SUBJECT: Entergy Nuclear Operations, Inc.  
James A. FitzPatrick Nuclear Power Plant  
Docket No. 50-333  
License No. DPR-59  
Emergency License Amendment Request Application for Technical  
Specification 3.8.1 Required Action B.4 Completion Time

**Emergency License Amendment Request Application  
for  
Technical Specification 3.8.1 Required Action B.4 Completion Time**

Proposed Technical Specification Changes (Mark up)

**Proposed Technical Specification Changes  
(Final Typed)**

**3.8.1-3**

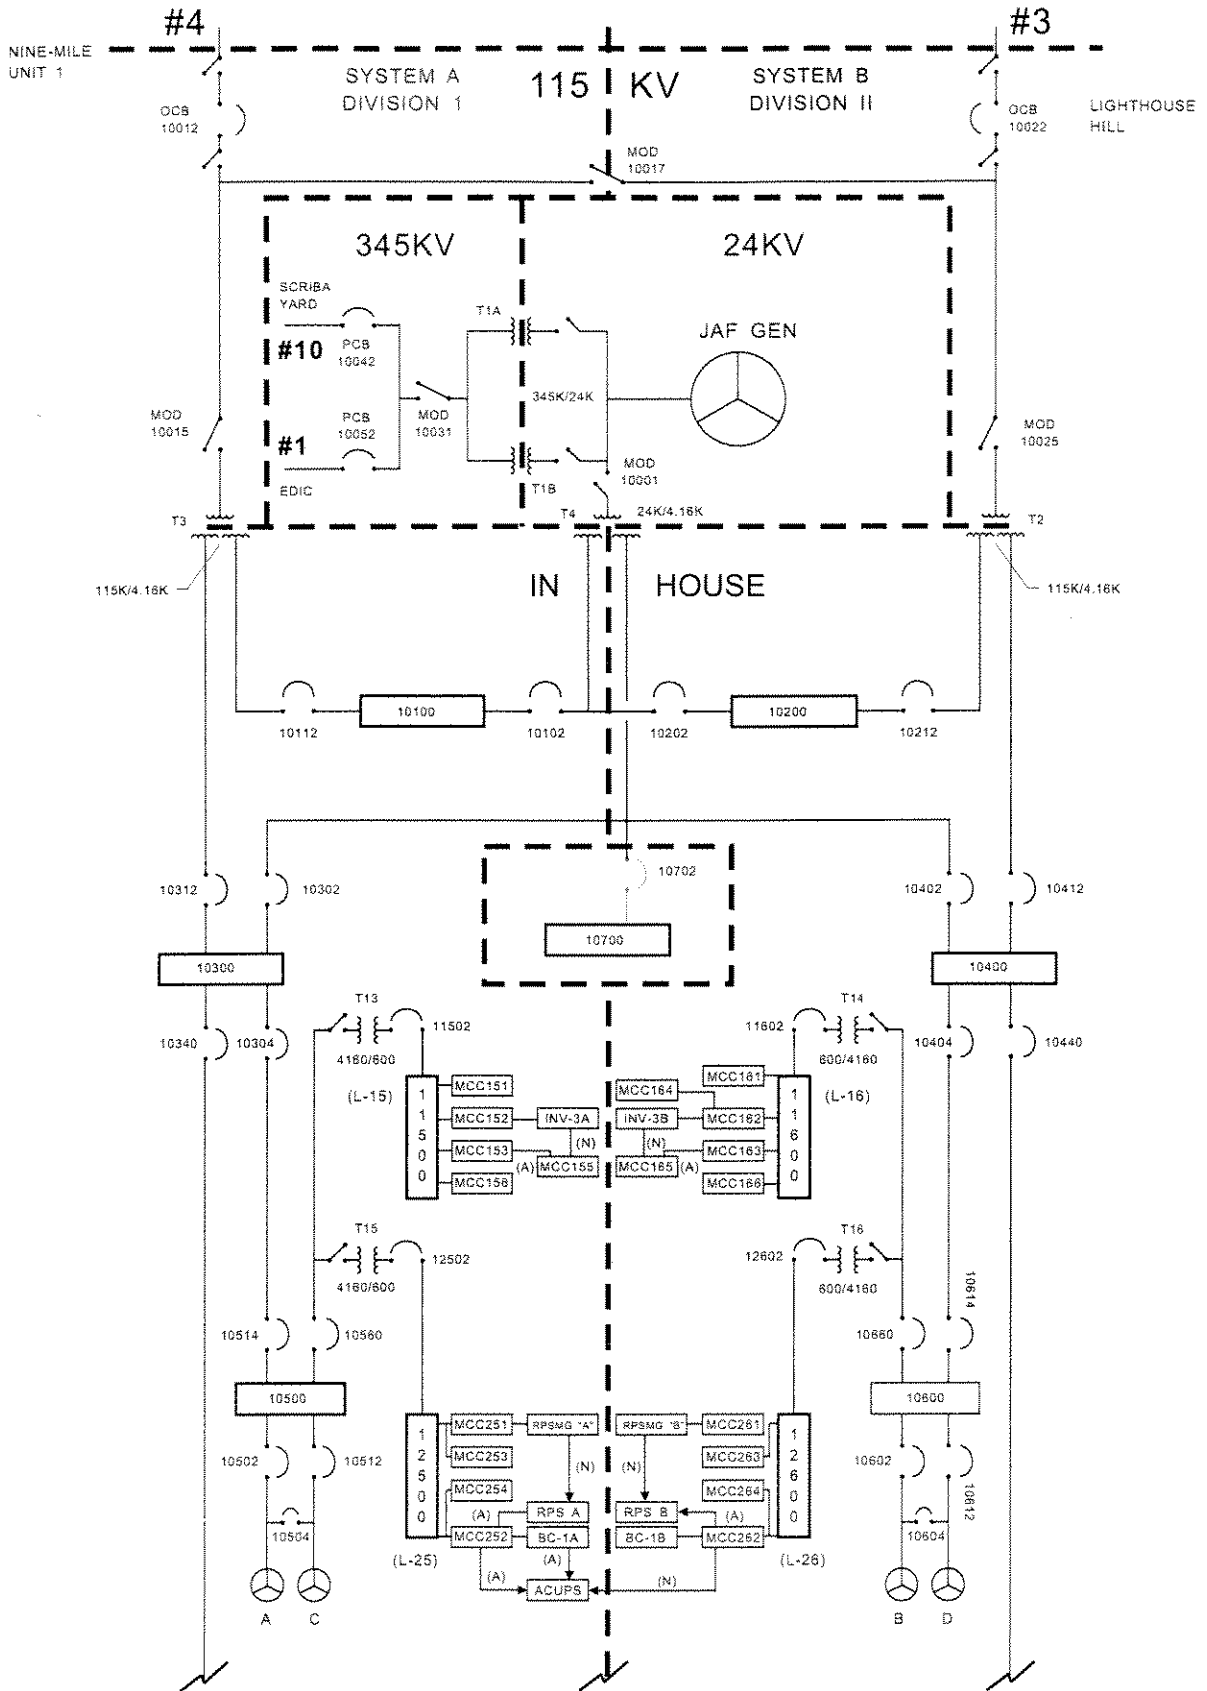
The proposed amendment would revise the Technical Specification (TS) 3.8.1 Required Action B.4 Completion Time, on a one-time basis by adding a footnote to the completion time. The proposed note would read "For the "A" EDG subsystem only the Completion Time that the subsystem can be inoperable as specified by Required Action B.4 may be extended beyond the "14 days and 21 days from discovery of failure to meet LCO" up to a total of 21 days as part of the 93EDG-C rotor repair. Upon completion of the repair and restoration, this footnote is no longer applicable and will expire at 1015 on June 16, 2009."
